E3633A-05D

S E R V I C E N O T E

E3633A DC Power Supply

Metal Strap Kit for tightening loose bumper and for fitting rear lock link in side-by-side rack mounting

Figure 2: Top view 3mm gap observed between two different chassis designs

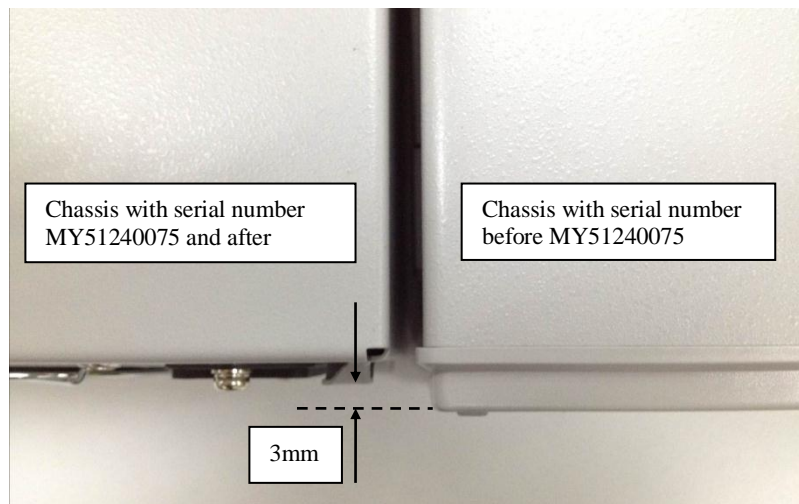
The chassis depth difference between the two designs is 3mm as shown in Table 1 and Figure 2 below.

Figure 3: Top view 3mm gap observed on rear lock link for side-by-side rack mounting

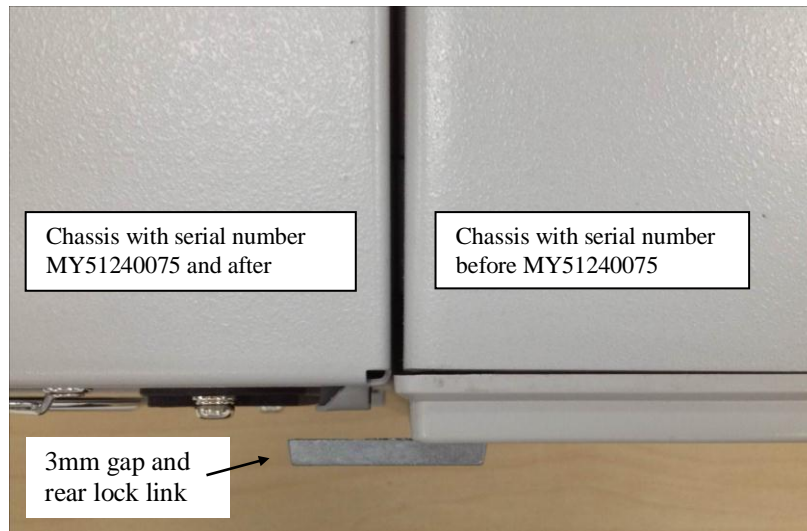
The 3 mm gap between the two different chassis may cause difficulties in securing them together using a rear lock link kit (part number 0050-2167) for side-by-side rack mounting as shown in Figure 3 below.

Use metal strap (part number E3631-07901), and stack the provided two metal straps together to form 3mm thickness and secure it with the provided screws on the rear lock link as shown in Figure 5 below.
